# Work Order ID 112721

Item Name: Aft Crosstube - High

DRAWING NO. D212-664-241	TITLE CROSSTUBE ASSY (205/212 HI AFT)	REV. D	DART AEROSPACE LTD ENGINEERING ORDER		D.E.O. NO. D212-664-241-D-1	SHEET NO. SHEET 1 OF 2	SCALE NTS
DRAWN	CHECKED	MFG. APPR.	APPROVED	DE APPR.			
DATE 11.04.07	DATE 11.04.11	DATE 11.04.12	DATE 11/04/12	DATE 11.04.12

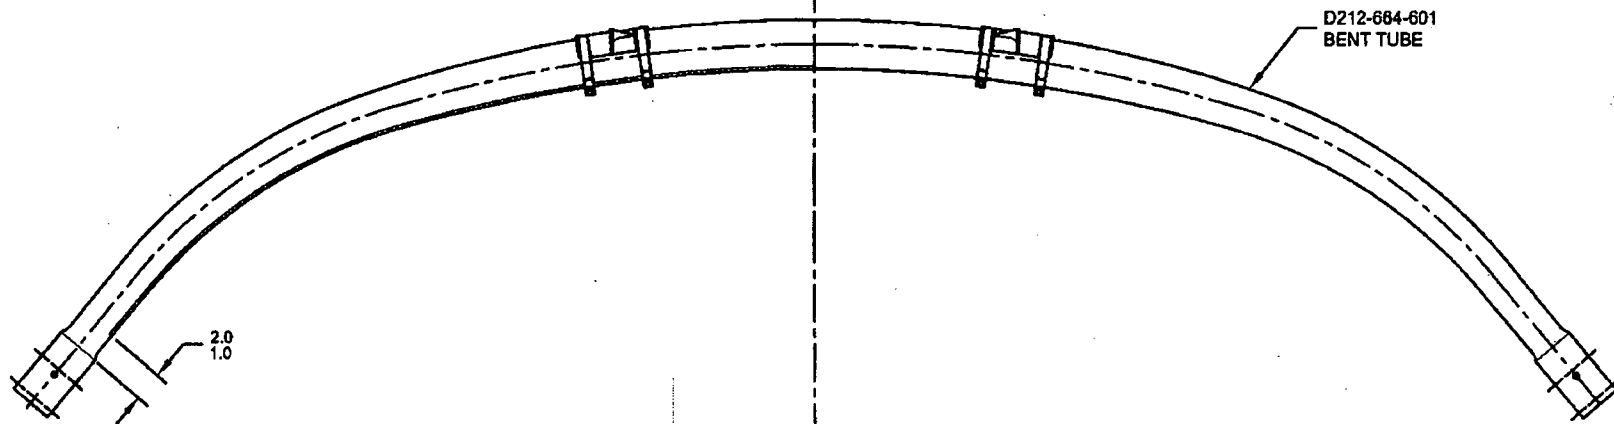
ADD AN INSPECTION WINDOW TO UNDERSIDE OF CROSSTUBE.

NOTES 2 OF SHEET 1 IS AMENDED AS FOLLOWS:

- 2) FINISH: CHEMICAL CONVERSION COAT PER DART QSI 005 4.1  
PRIME INSIDE AND OUTSIDE PER DART QSI 005 4.2  
MASK UNDERSIDE OF CROSSTUBE AS SHOWN (HATCHED AREA) AND  
PAINT OUTSIDE PER DART QSI 005 4.2  
REMOVE MASKING AND APPLY CLEAR COAT

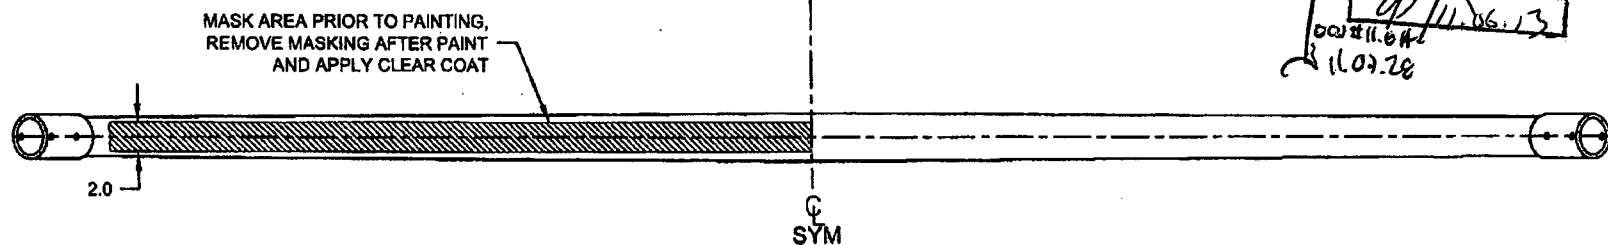
REPLACE MAGNOBOND WITH PROSEAL.

NOTE 12 & 15, SHEET 1 IS AMENDED AS FOLLOWS:

- 12) TO INSTALL D2940-1 SUPPORT: ABRABE MATING SURFACE OF SUPPORT AND CROSSTUBE WITH 180-GRIT SANDPAPER AND REMOVE RESIDUE WITH MEK (OR EQUIVALENT). APPLY A 0.04" TO 0.07" THICK LAYER OF PROSEAL 890 CLASS B-2 (OR AMS-S-8802 CLASS B-2) SEALANT TO MATING SURFACE OF SUPPORT.
- 15) TORQUE CLAMPS 80 TO 100 IN-LB. ENSURE AT LEAST 1.5 THREADS SHOWING IN SAFETY AND THAT NUT HAS NOT BOTTOMED-OUT AFTER TORQUING. **PRIOR TO PACKAGING, RE-CHECK TORQUE ON CLAMPS AFTER PROSEAL 890 SEALANT HAS CURED FOR 72 HOURS.**

**FIGURE 1: SUPPORT INSTALLATION**

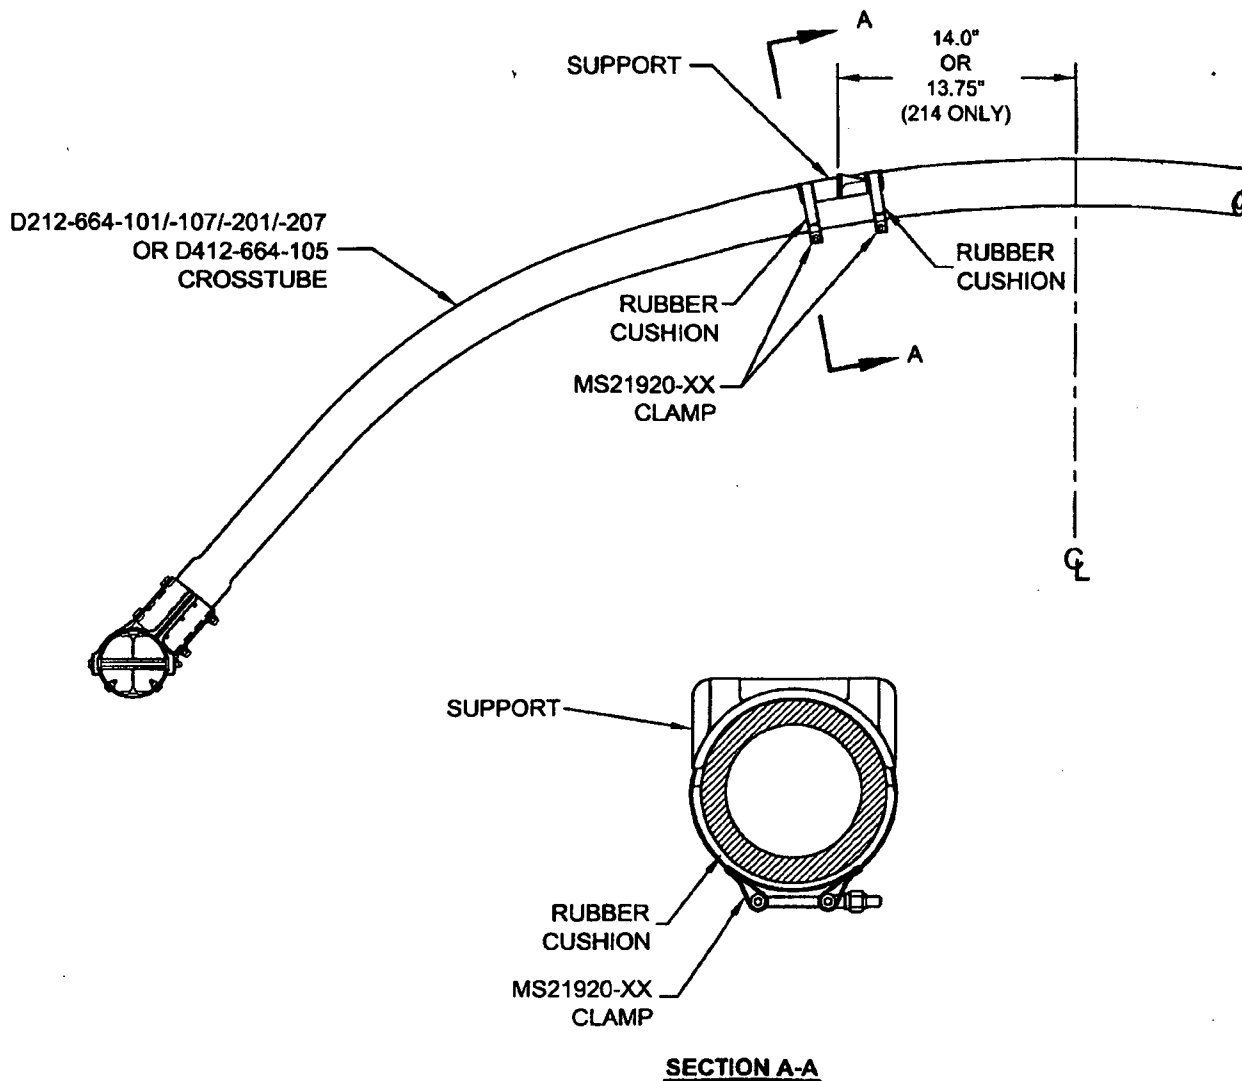
For the crosstubes listed above, section 32.4 of ICA-D212-664 is amended as follows. Use Figure 1 of this service instruction and Figures 32-2 to 32-9 of ICA-D212-664 for further reference. For crosstubes of an earlier change number, it is recommended that if the supports are removed, the supports should be reinstalled using the procedure listed below.

- 32.4.1 Locate the area on the crosstube for installation of support (see Figure 1 of this service instruction). For D212-664-101/-107/-201/-207 and D412-664-105 crosstubes, the outward face of the support tabs should be 14.0" (355mm) from the crosstube center for 204/205/210/412/UH-1 aircraft. For installation on 214B/B-1 aircraft, the outward face of the support tabs should be 13.75" (349mm). Ensure paint finish of crosstube is intact; touch up as required per Chapter 5 (5.3.9) of ICA-D212-664.

- 32.4.2 If present, remove any paint/primer on bottom of supports. Abrade mating surfaces of support and crosstube with 400-grit sandpaper. Saturate a clean cloth with MEK or 4105S Wash'n'Wipe Degreaser or equivalent and wipe until there is no residue.

- 32.4.5 Apply a 0.04" to 0.07" thick layer of Proseal 890 Class B or AMS-S-8802 Class B sealant underneath applicable support and install support as shown in Figure 1 of this service instruction.

- 32.4.6 Install the clamps opposite to crosstube support as shown in section A-A of Figure 1. Install rubber cushions underneath each clamp around the bottom circumference of the crosstube up to the crosstube centerline. Torque clamps 80-100 in-lb (9.0-11.3 Nm). It is acceptable to use smaller or larger sized MS21920-XX clamps than those listed in ICA-D212-664, ensure that after torquing the clamps per this instruction, the nuts are in safety but not bottomed out
